Intel[®] Xeon[®] Processor E5 Family

Specification Update

July 2014

11. Datasheet Volume 2: Figure 1-1 Processor Integrated I/O Device Map.

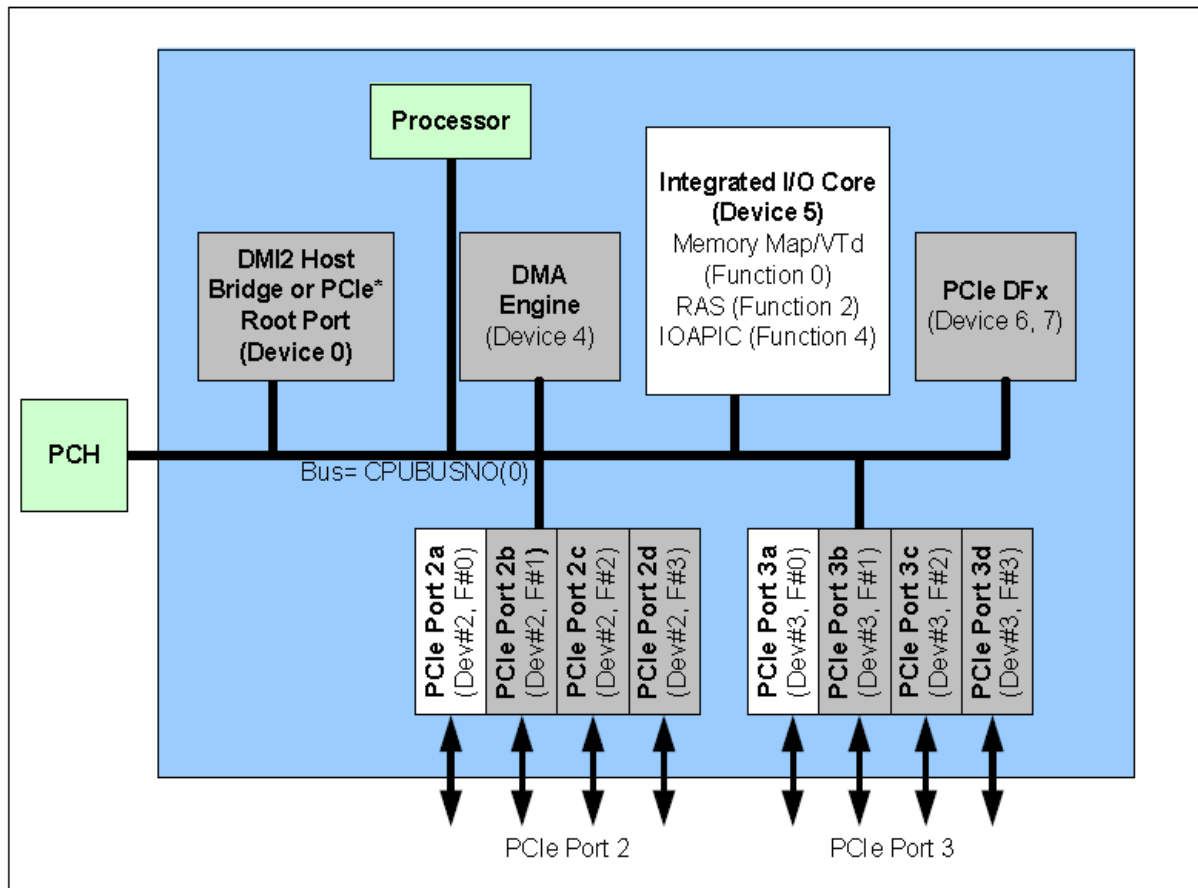
The drawing in the current EDS Volume 2 does not include devices 6 and 7. These are internal devices not generally accessible on production systems. The drawing below is correct.
